PROJECT REVIEW COMMITTEE - CITY OF WILDWOOD

Agenda

1. **SP 2204-004 Freedom Fellowship Church
Parcel D33-020**

2. **SP 2310-004 Wildwood Self Storage**

DATE: DEC 2021 SHEET: C-4.1

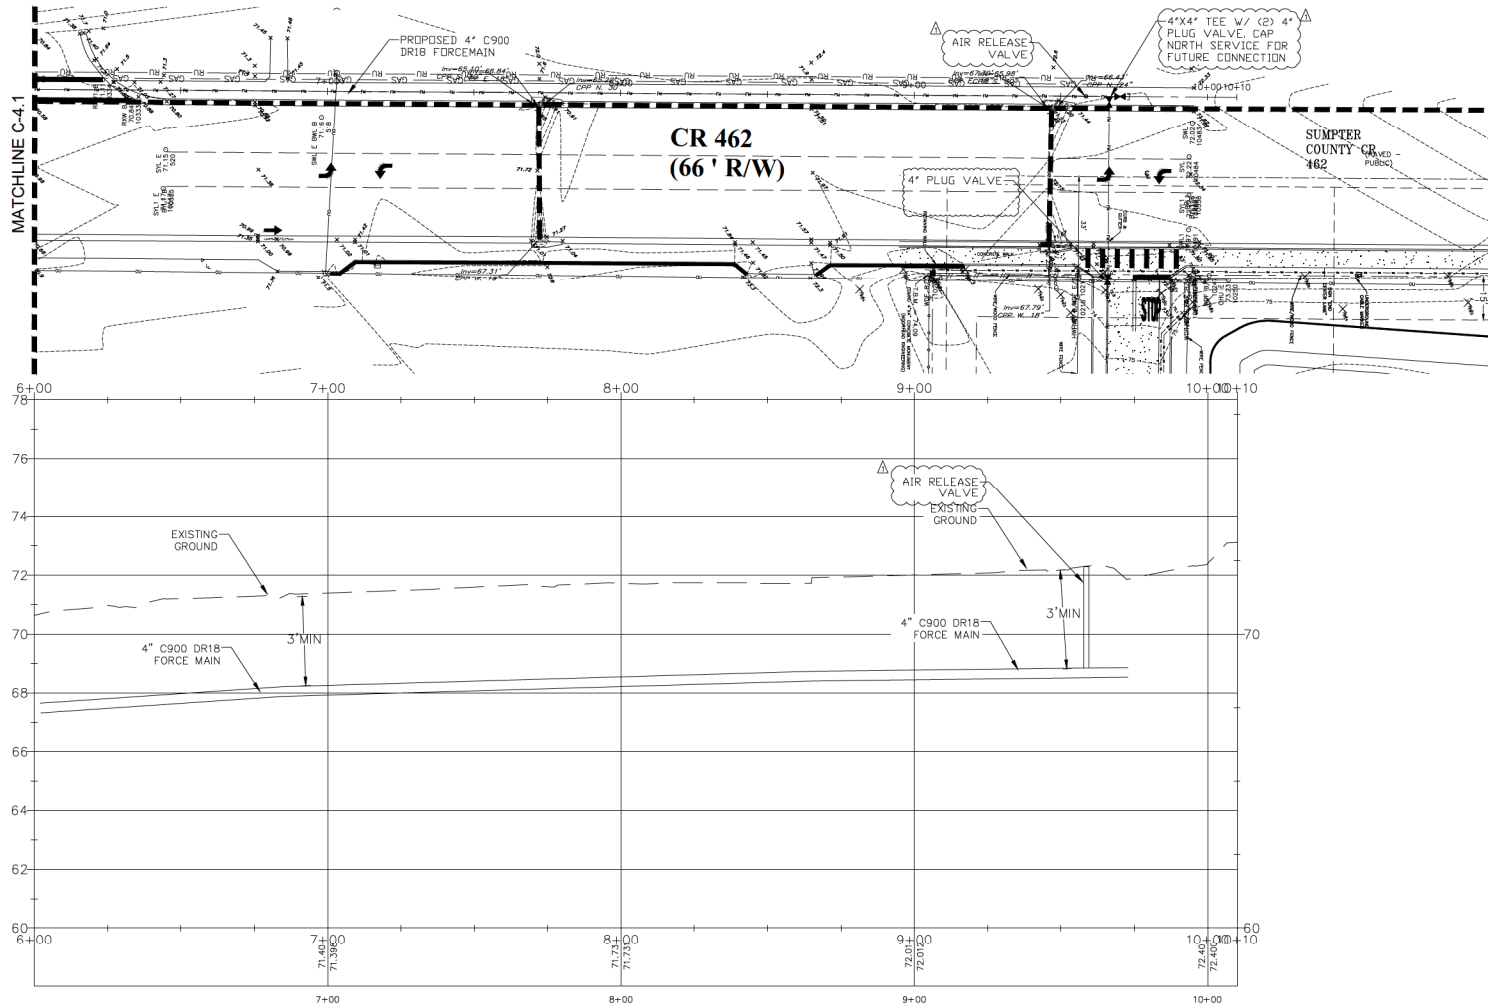
1. Sheet C4 Utility Plan, General Utility Notes #23: New city water, sewer, and re-use details are available on the city's web site – www.wildwood-fl.gov in the Development Services department. Some of the detail sheets have changed. Please verify and adjust accordingly.
2. Sheet C4 Utility Plan: At the dead end of the 10" water main, please refer to city water detail sheet W-12, Automatic Blow Off. The proposed 460 LF of water main will become stagnant without proper flushing. Replace regular 2" blow off.
3. Sheet C-1 Notes and Specifications: Section XV. Water, Sewer, Distribution and Collection System Notes states "Water meter valves shall be installed by the governing municipality." Remove the statement as that is part of the construction process performed by the contractor. The city will install meters only.

UTILITY PLAN
SHEET **C500**

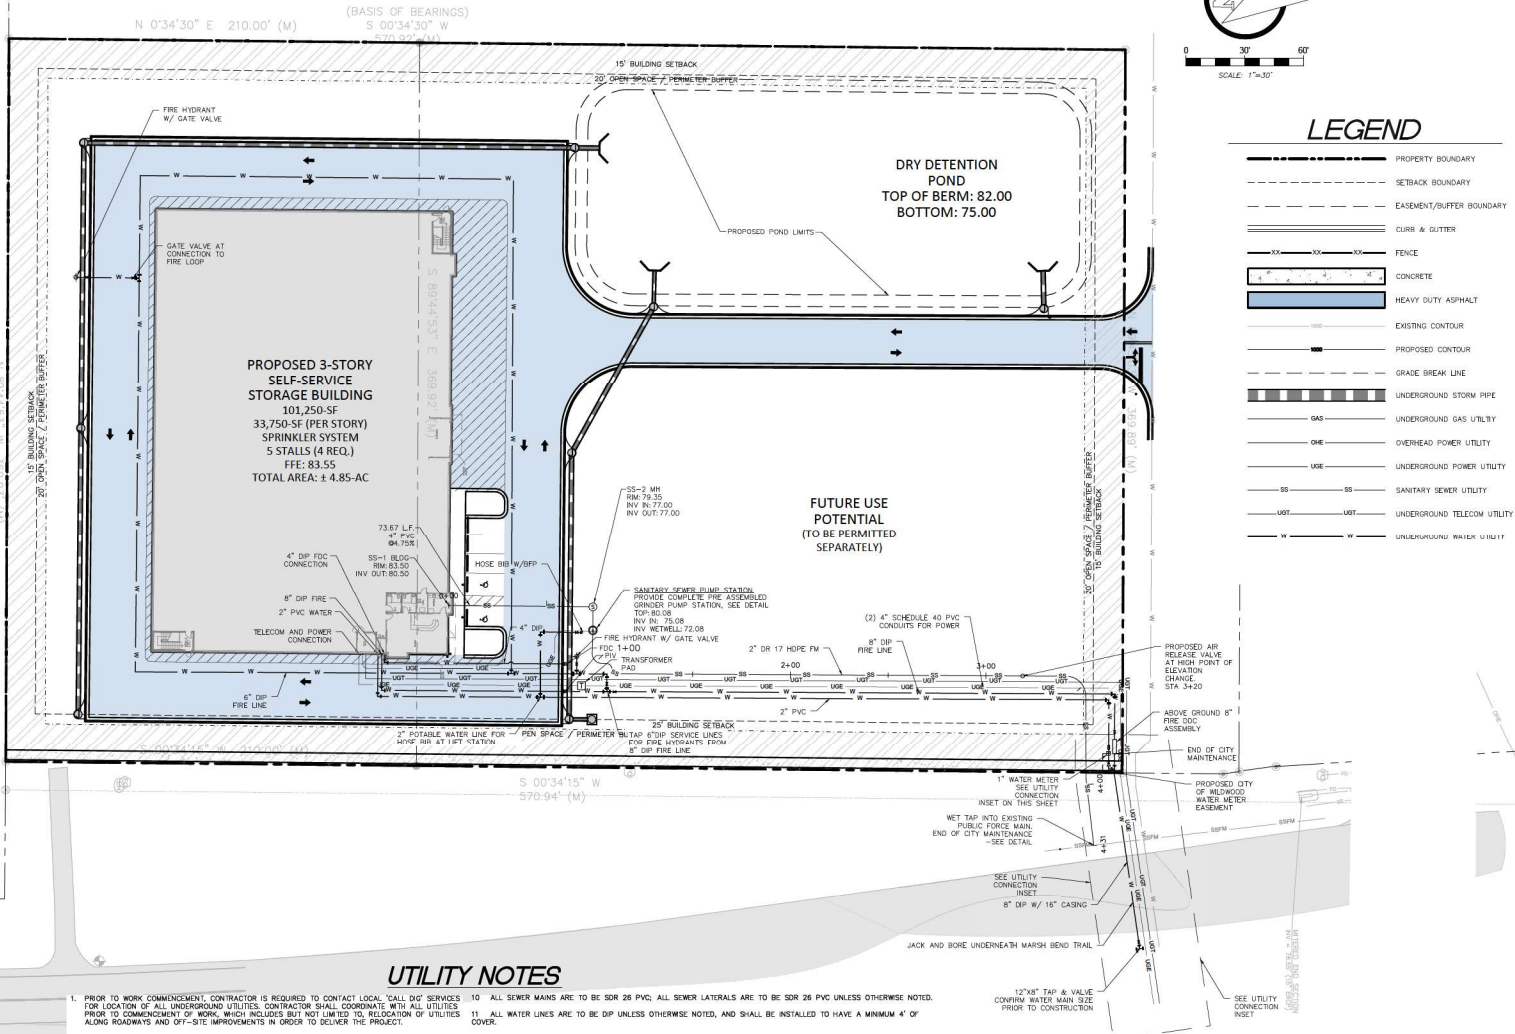
- 2. Sheet C500 – It appears that an easement may be necessary to accommodate proposed water connection. Please add a note to utility plan showing proposed end of city maintenance for water connection to clarify. (Partially Satisfied. As it does not appear that there is an easement for city utilities on proposed site, please submit an easement application. If there is an easement, please clearly mark the easement on the site plan.)

- I. Not Satisfied. Plans do not appear to show what was stated in the response. Additionally, the end of city maintenance note shows the City's side of utilities on the property at issue.

1. Sheet C500 Utility Plan:

A. RESPONSE: After discussions with the residential development behind the property we will now be utilizing a private pump station and tying into the public forcemain.

a. RESPONSE: Apologies for misinterpreting the initial comment. Easement is now shown up to the water meter and end of city maintenance is called out on the utility sheet.

SANITARY SEWER PROFILES
SHEET **C501**

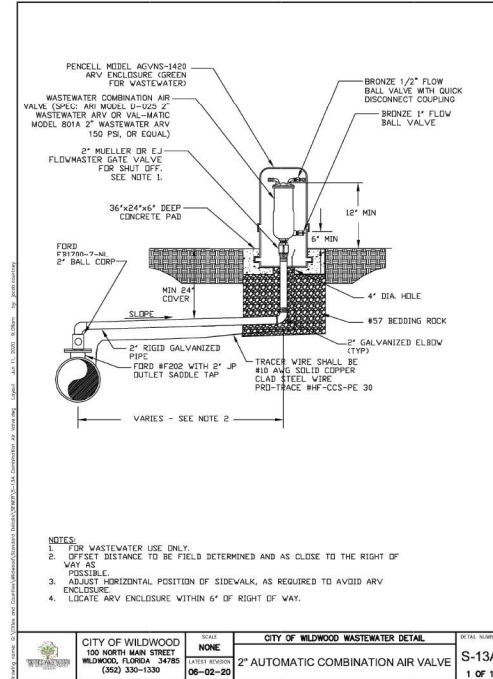
2. Sheet C501, C503, C701, C702, C703: Update and replace City of Wildwood specifications and detail sheets to the latest version, dated 2024.
3. Sheet IR-1 Irrigation Plan:
